DEVELOPMENT REVIEW BOARD PANEL A AGENDA

2. [Resolution No. 405 Boones Ferry Gas Station. The applicant is requesting approval of a Stage I Preliminary Plan Modification, Stage II Final Plan, Site Design Review, Class 3 Sign Permit, Sign Waiver and Type C Tree Plan for construction of a 2,999-square-foot convenience store with drive-thru and 12-pump fuel station.](#)

Exhibit A1
Staff Report
Wilsonville Planning Division
Boones Ferry Road Gas Station and Convenience Store

Preliminary Utility Plan For:

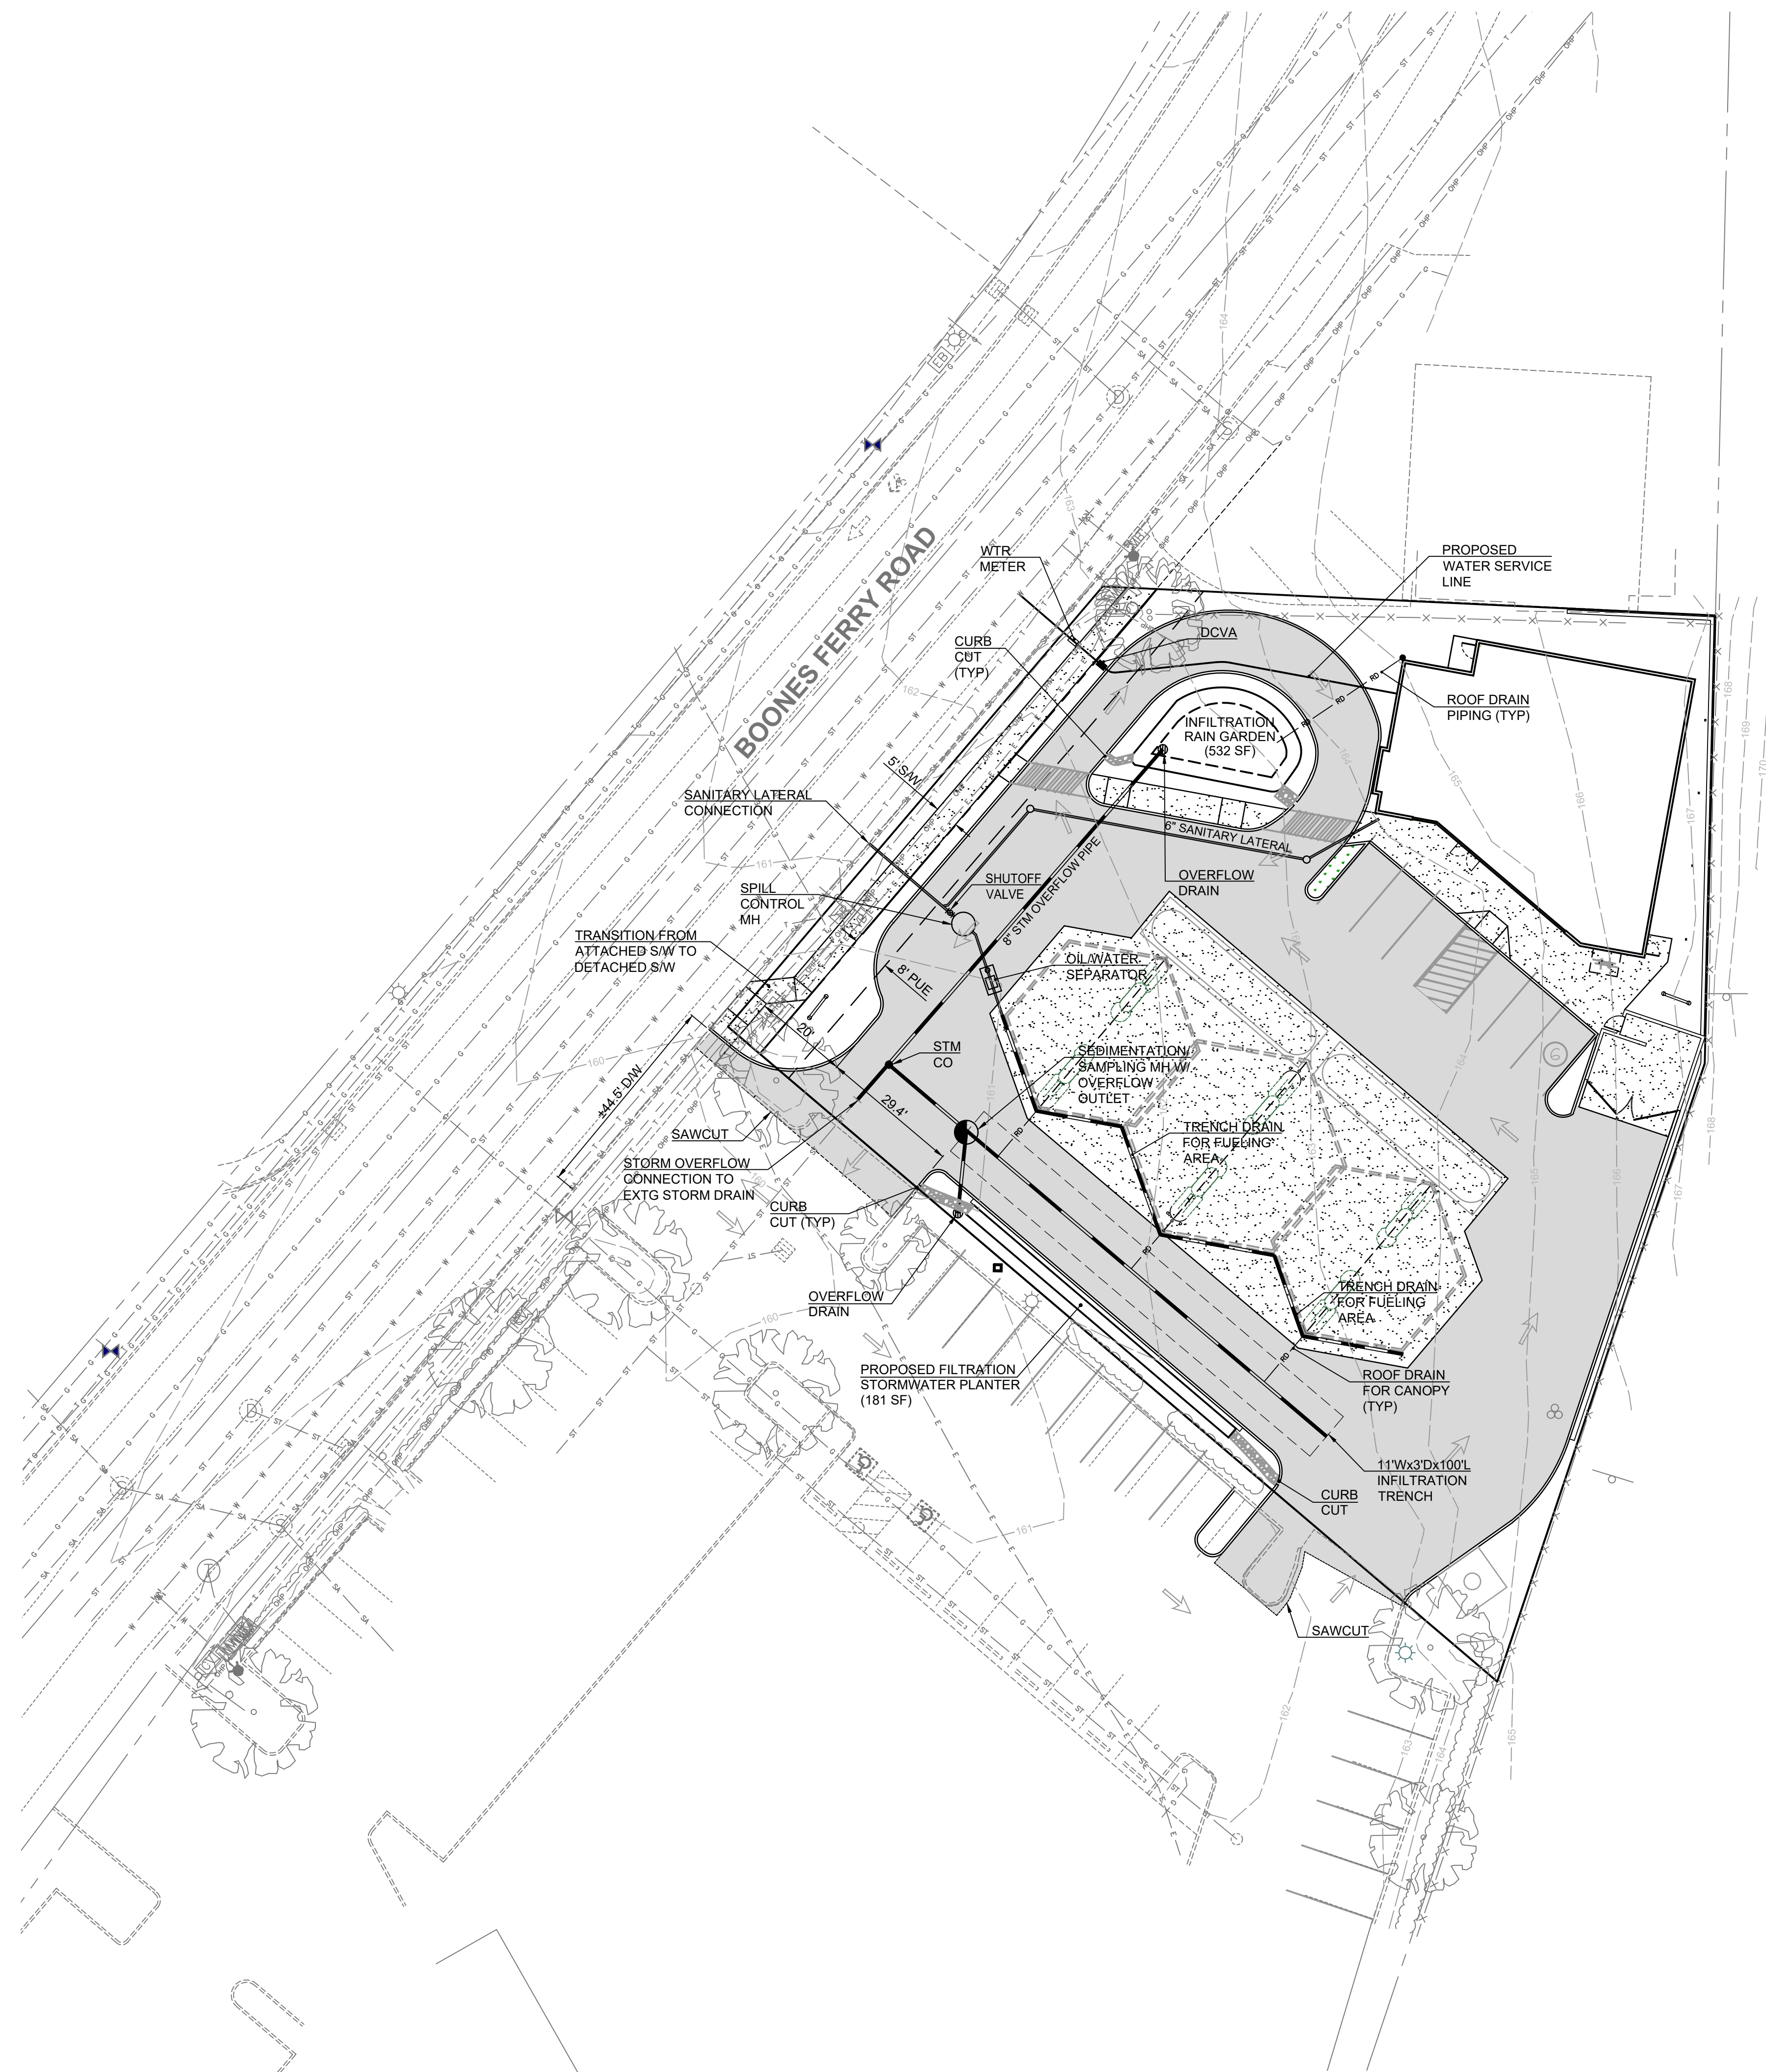
- A. Provide utility plan showing utility connection locations.
 - *See Preliminary Utility Plan on C2.*
- B. Show dedication for Boones Ferry Road. New right-of-way line shall be 11.5 feet from face of curb. Dedications ranges from 8.85 to 9.25 feet based upon survey data.
 - *See right-of-way proposed on Schematic Site Plan A0.1.*
- C. Show 8-foot Public Utility Easement (PUE) along Boones Ferry Road right-of-way frontage.
 - *See 8' PUE shown on the Boones Ferry Rd side; see Schematic Site Plan on A0.1.*
- D. Curb tight sidewalk not allowed. Provide 6 foot wide planter strip and 5 foot wide

1 **NORTH EXTERIOR ELEVATION**
SCALE: 1/4" = 1'-0"

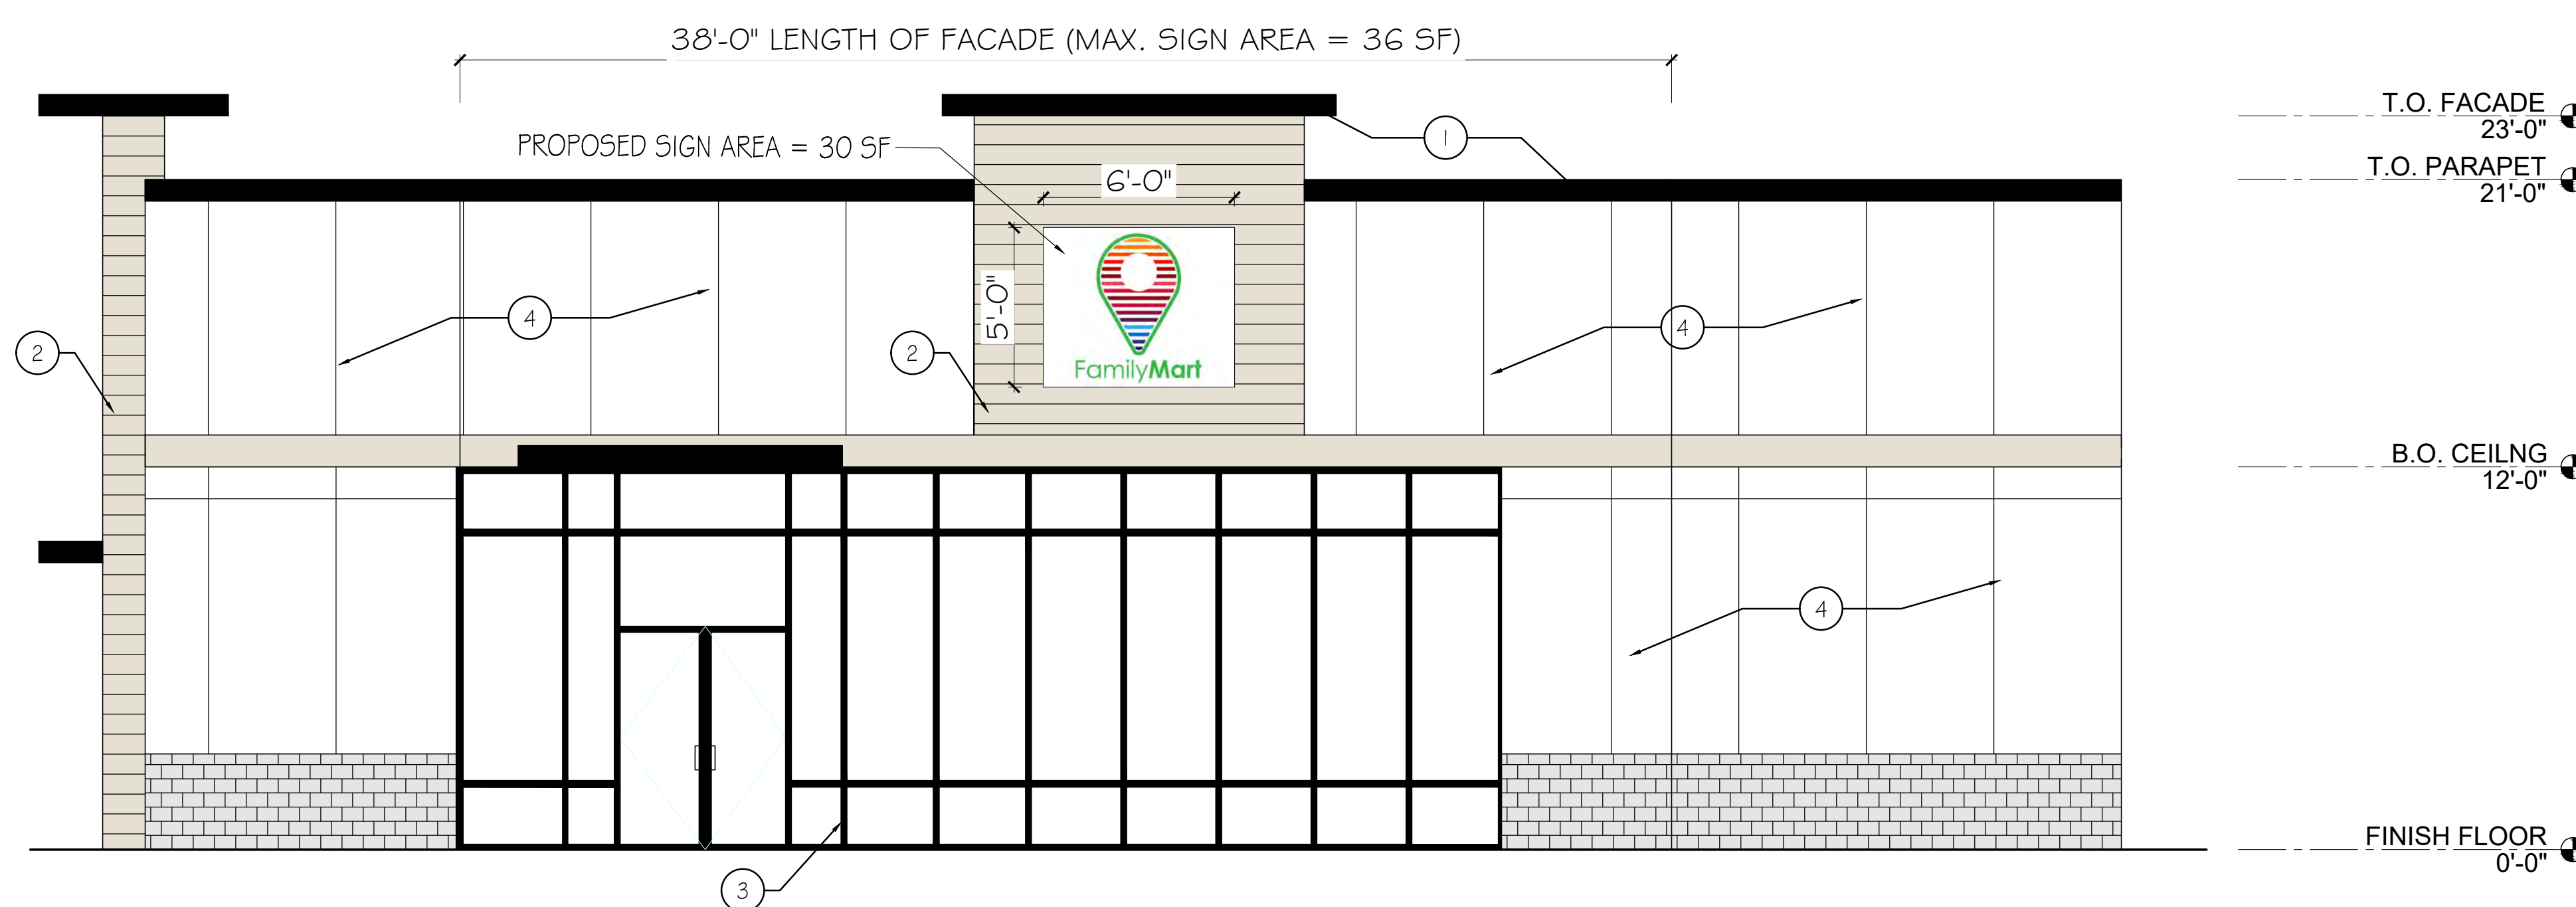
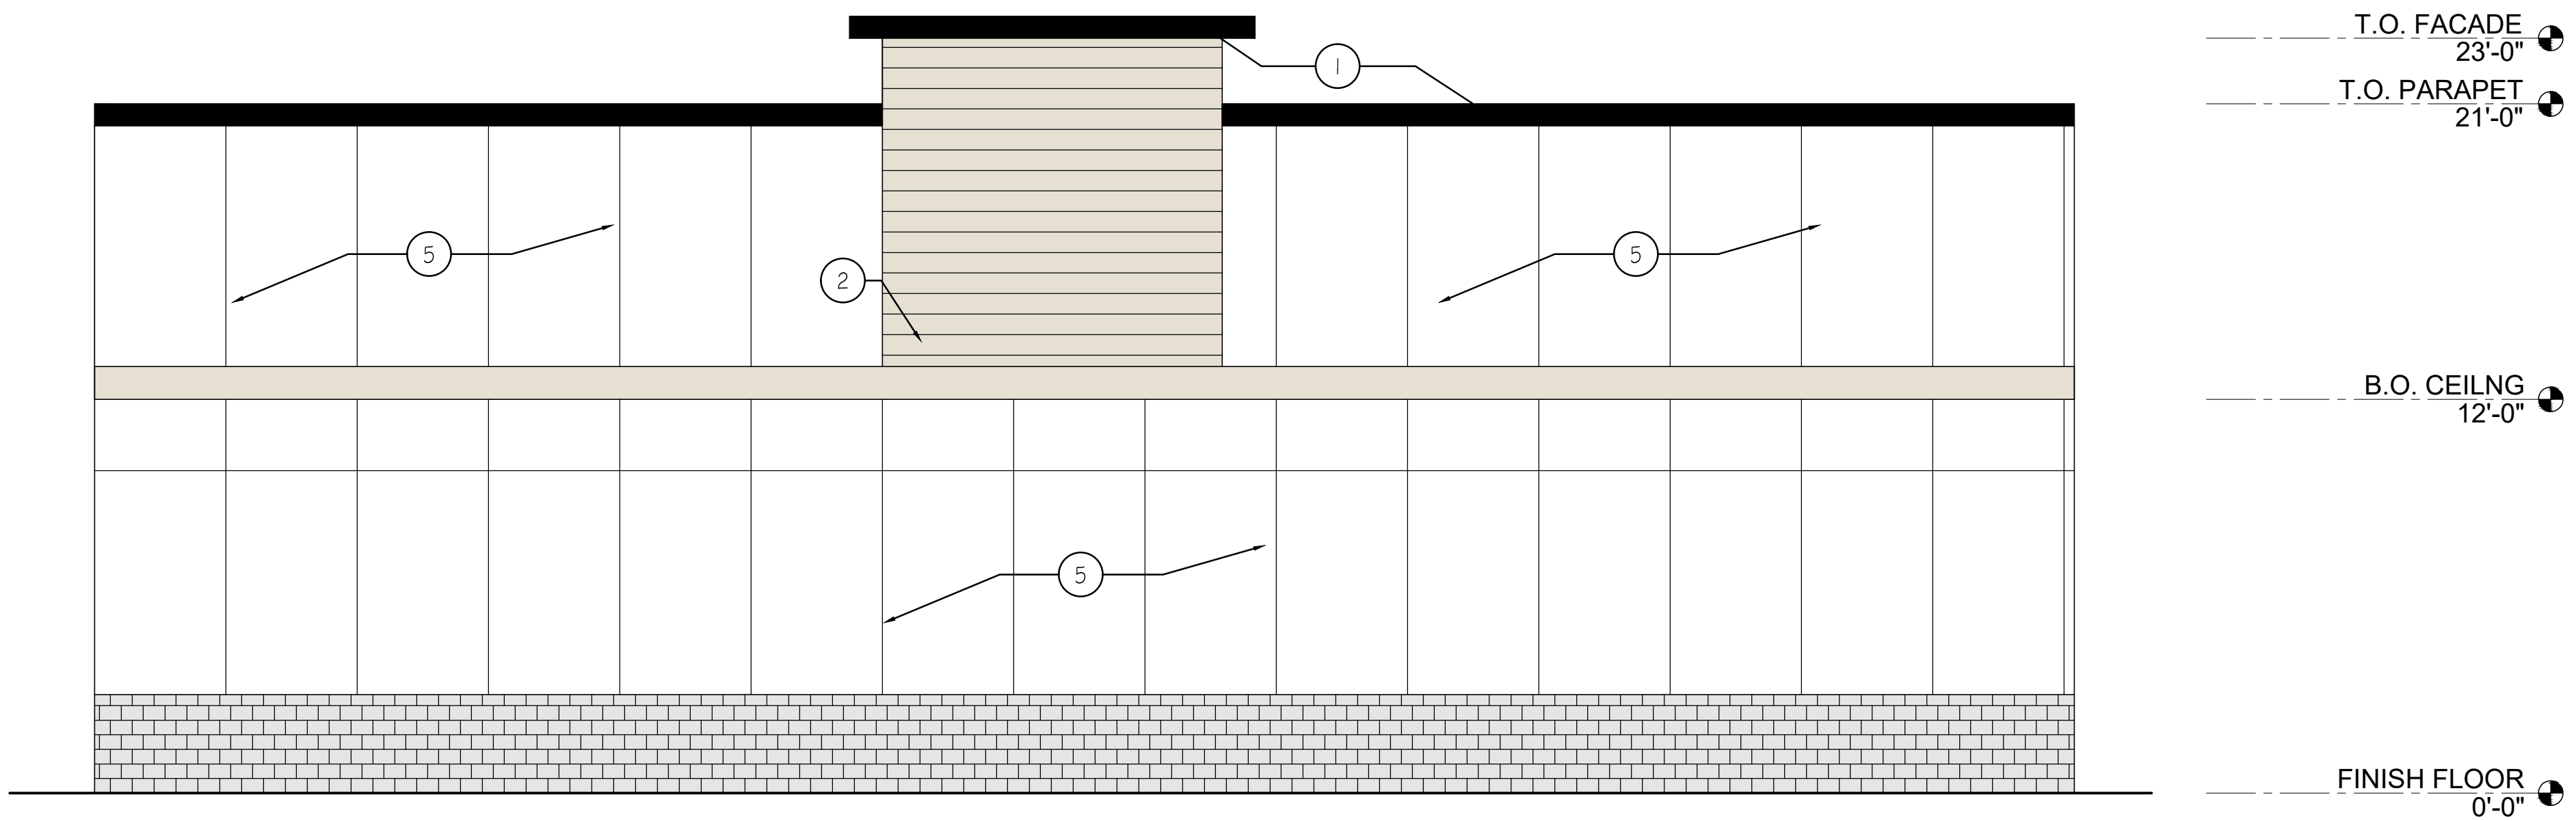
- Details on outdoor furnishings (bike rack, garbage cans, lighting, benches, etc.)
 - *See site details on A0.2.*
 - East elevation indicates exterior doors not shown on other plans

- *East elevation revised to show exterior door; see A2.0.*
 - Revised elevations showing sign locations and designs.
 - *The sign permit is to be a separate submittal later on.*
